PUBLIC INTEREST REVIEW FOR GROUNDWATER APPLICATIONS

TO: Water Rights Section Date 12/30/2014
 FROM: Groundwater Section Jen Woody
Reviewer's Name
 SUBJECT: Application G- 17932 Supersedes review of n/a
Date of Review(s)

A. GENERAL INFORMATION: Applicant's Name: Wigrich Farm, Inc. by Roger Fitts County: POLK

Transient Stream Depletion (Jenkins, 1970; Hunt, 1999, 2003)

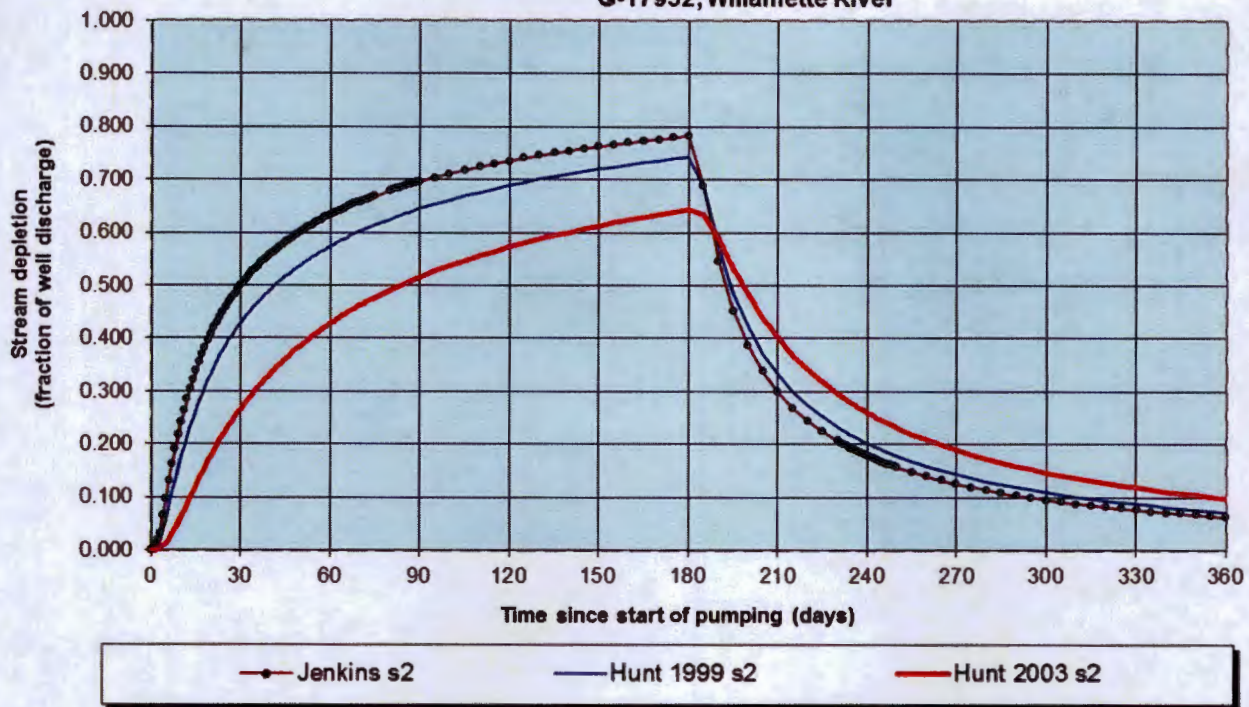
Output for Stream Depletion, Scenerio 2 (s2):						Time pump on (pumping duration) = 180 days						
Days	30	60	90	120	150	180	210	240	270	300	330	360
J SD	49.9%	63.3%	69.6%	73.5%	76.2%	78.3%	29.9%	17.8%	12.5%	9.5%	7.6%	6.3%
H SD 1999	42.9%	57.4%	64.5%	68.9%	72.0%	74.3%	33.2%	20.2%	14.3%	10.9%	8.8%	7.2%
H SD 2003	26.75%	42.81%	51.59%	57.27%	61.32%	64.40%	40.09%	26.02%	18.92%	14.66%	11.84%	9.85%
Qw, cfs	3.300	3.300	3.300	3.300	3.300	3.300	3.300	3.300	3.300	3.300	3.300	3.300
H SD 99, cfs	1.416	1.893	2.128	2.274	2.375	2.451	1.095	0.666	0.472	0.361	0.289	0.239
H SD 03, cfs	0.883	1.413	1.702	1.890	2.024	2.125	1.323	0.859	0.624	0.484	0.391	0.325

Theis Drawdown and Recovery at r = 150 ft From Pumping Well

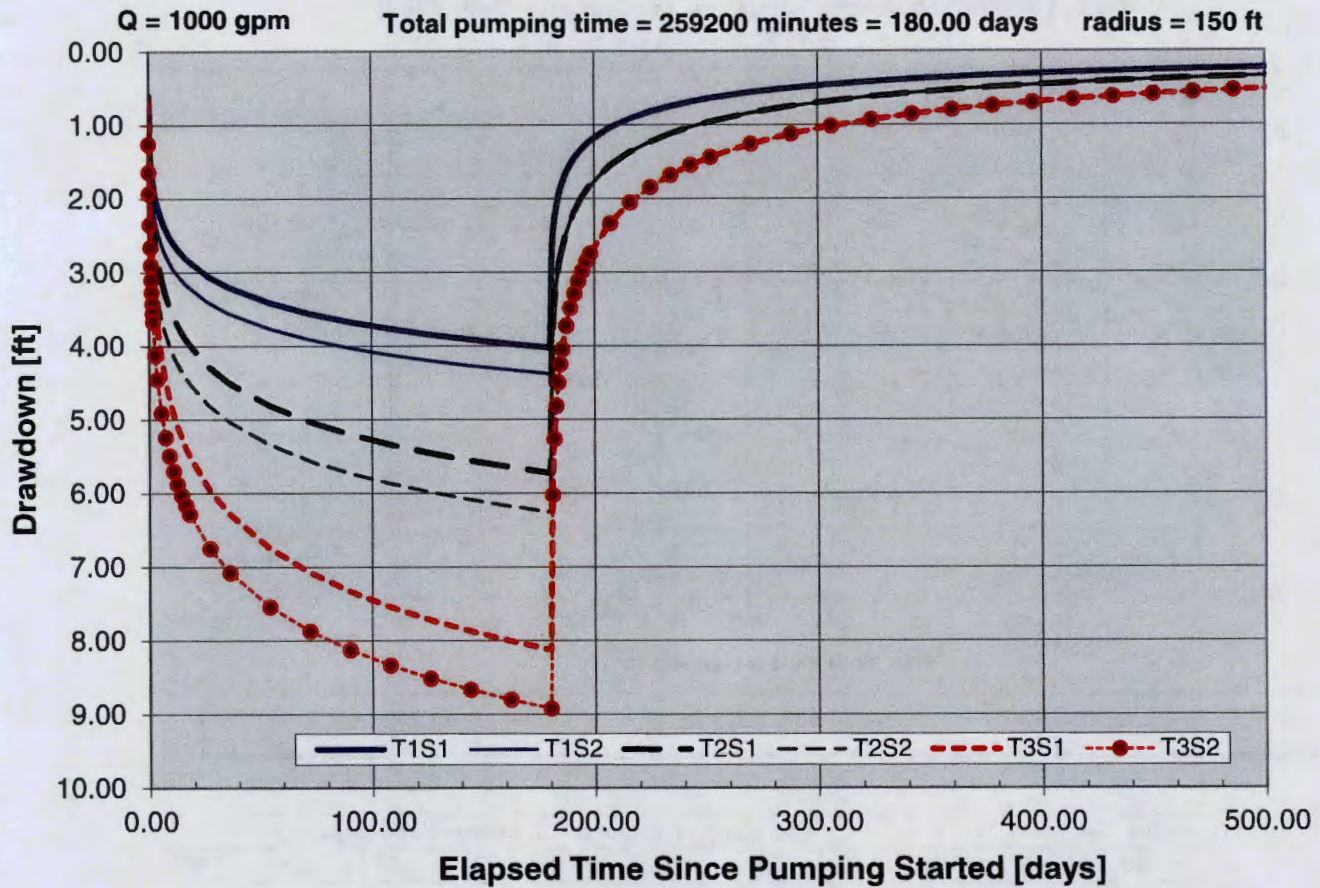
Other groundwater rights within a quarter mile of the proposed well are held by Wigrich Farm or Mr. Fitts. Claim GR 65 is the nearest POD; location accuracy is questionable but the estimated distance is 150-300 feet between the proposed POA and that claim. Based on $T = 225,000$ gpd/ft ($\sim 30,000$ ft²/d) and $S = 0.2$, nad a pumping rate of 1000 gpm, well to well interference will likely be less than 5 feet at 150 feet after 180 days of pumping (see attached Theis drawdown estimates).
